**SUPERIOR CHARTER TOWNSHIP
ZONING BOARD OF APPEALS
3040 N. PROSPECT RD., YPSILANTI, MI 48198**

**WEDNESDAY
JANUARY 12, 2022
7:00 P.M.
AGENDA**

**SUPERIOR CHARTER TOWNSHIP
ZONING BOARD OF APPEALS
DRAFT MINUTES
NOVEMBER 10, 2021
PAGE 1 of 3**

Sheet Title:
Architectural Site Plan
Released For: Permit

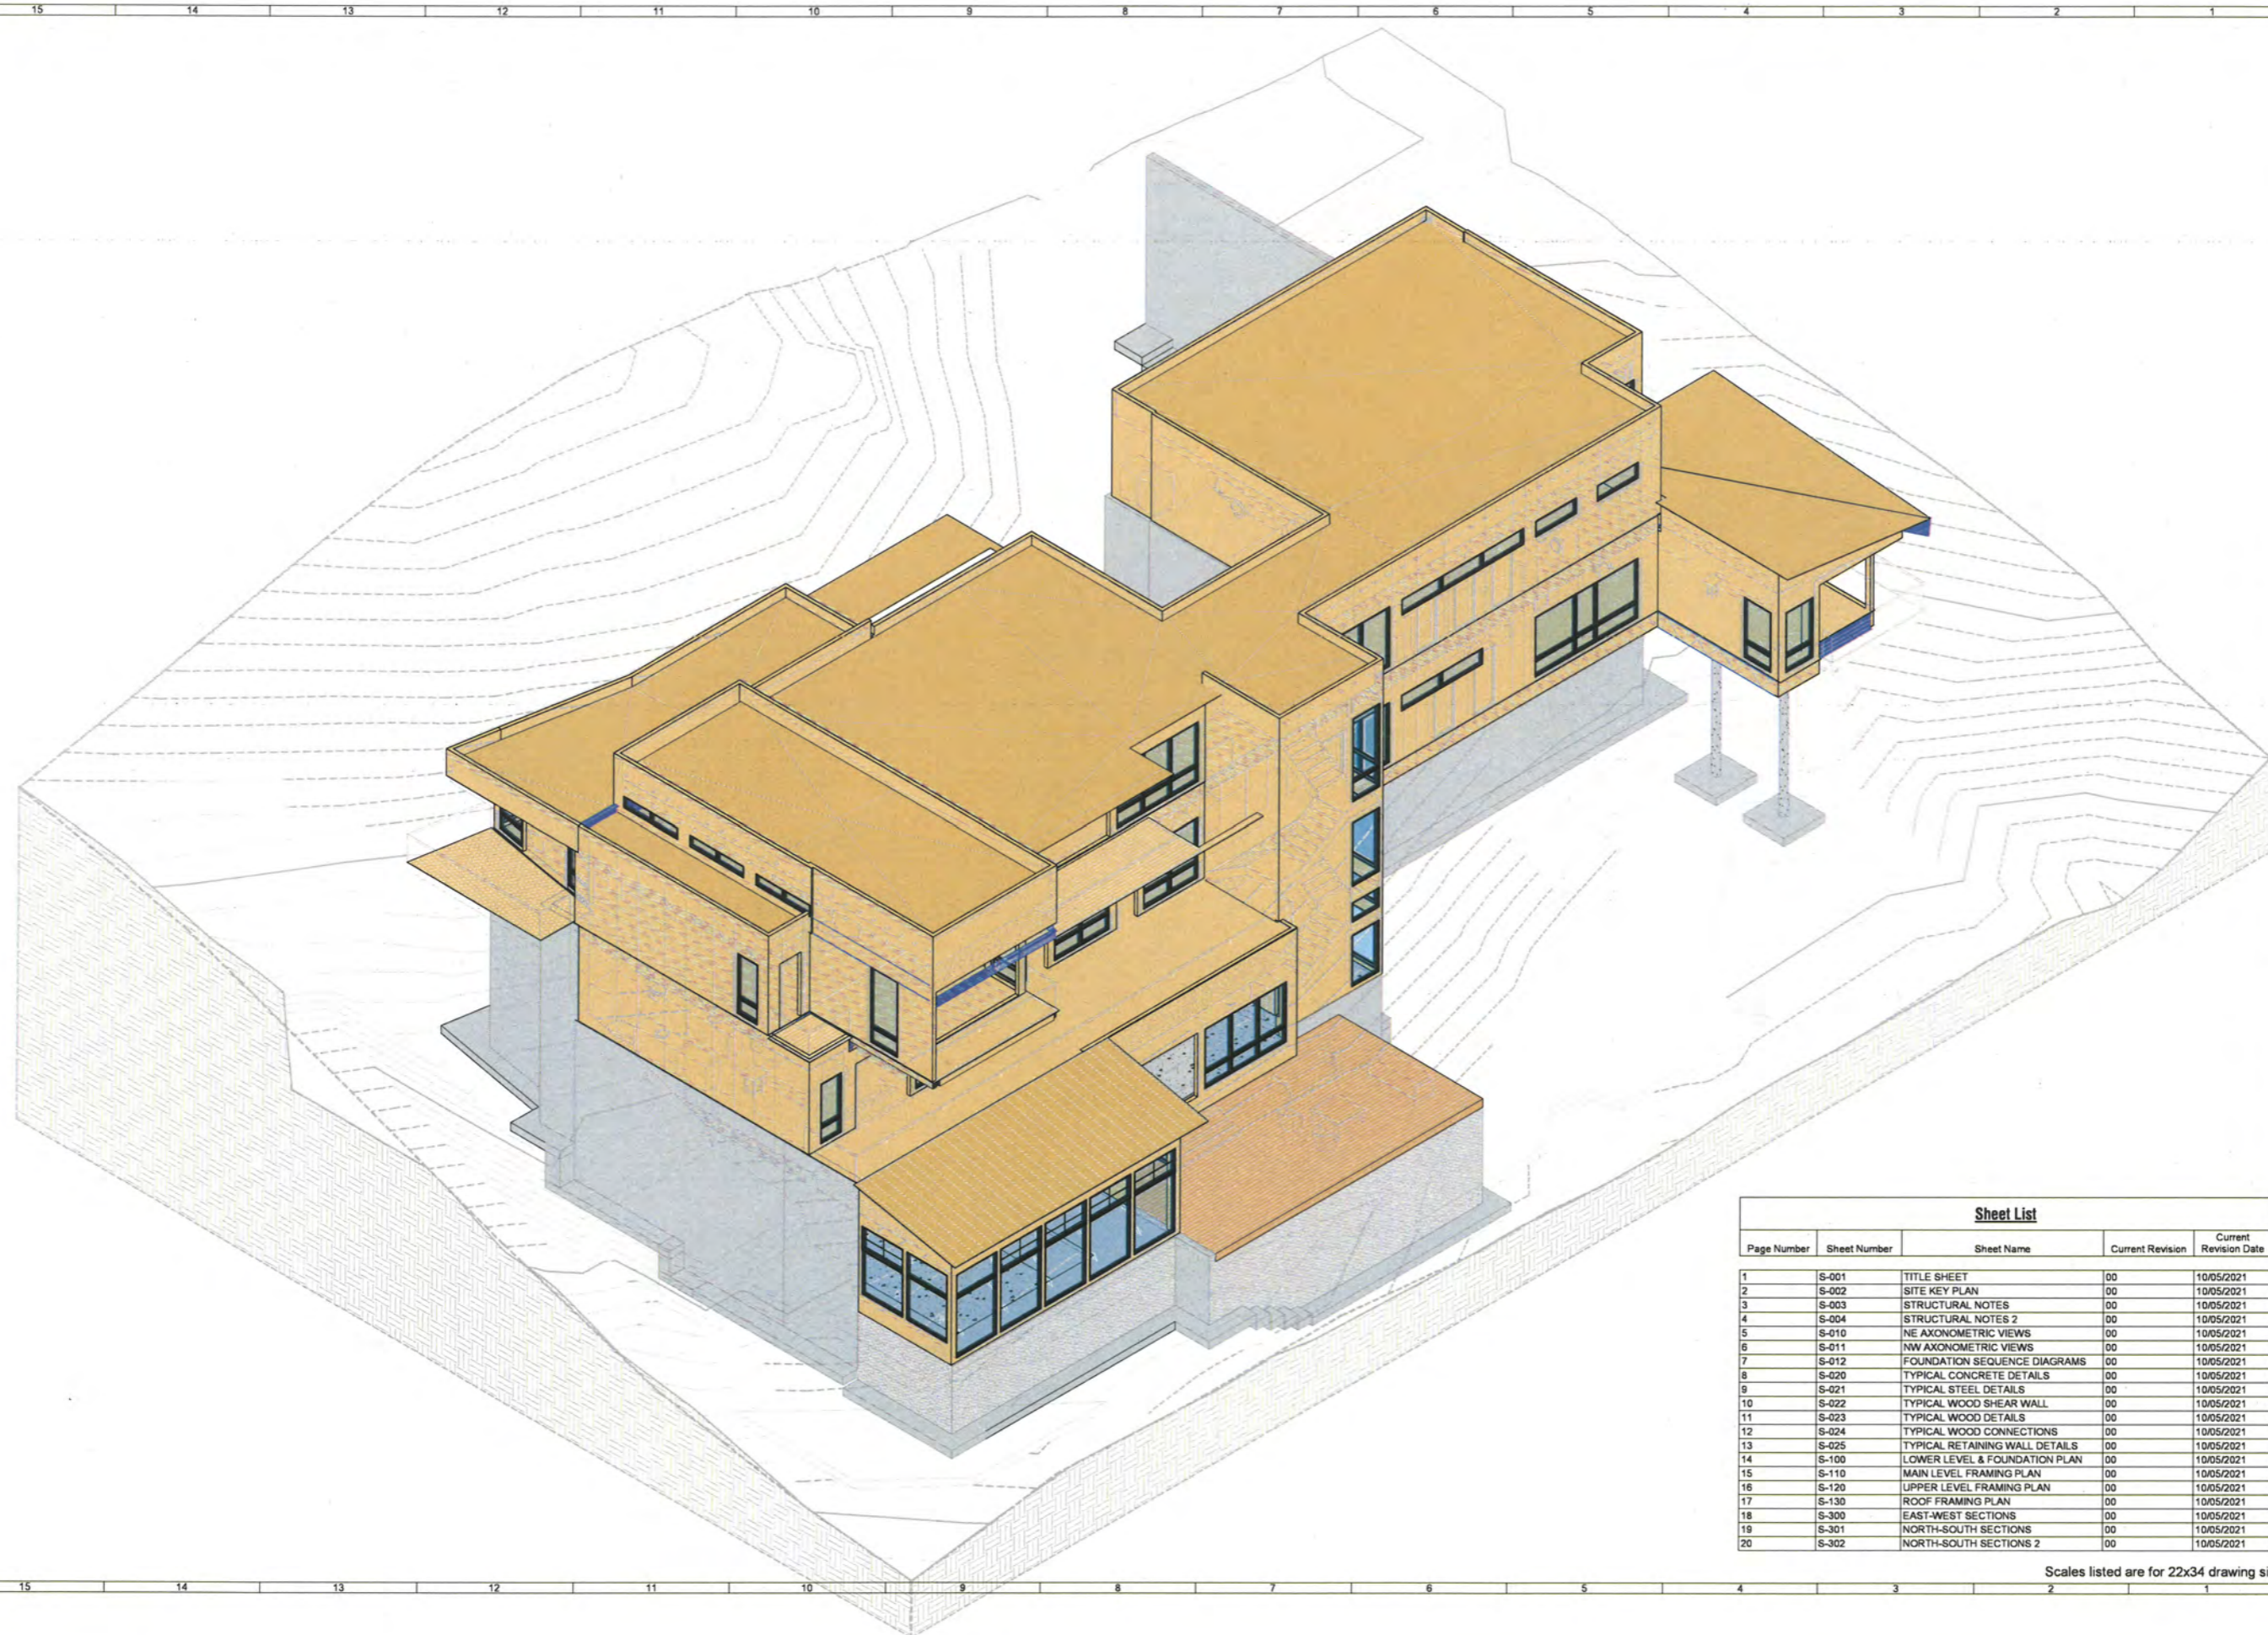
2. The submitted site plan (sheet G-201) is not adequate. The private road easement is not illustrated. The limits of the wetlands are not illustrated. Grading elevations and storm water management elements are not shown. Specific locations, heights and designs of site retaining walls are not shown on the site plan nor elsewhere on the plans.

3. Sheets G-100 and G-201 indicate conflicting home and garage square footage – which is correct?
4. Notes on sheet S-012 indicate “construction surcharge on retaining wall to be determined.” Who will be determining the surcharge if not the engineer?
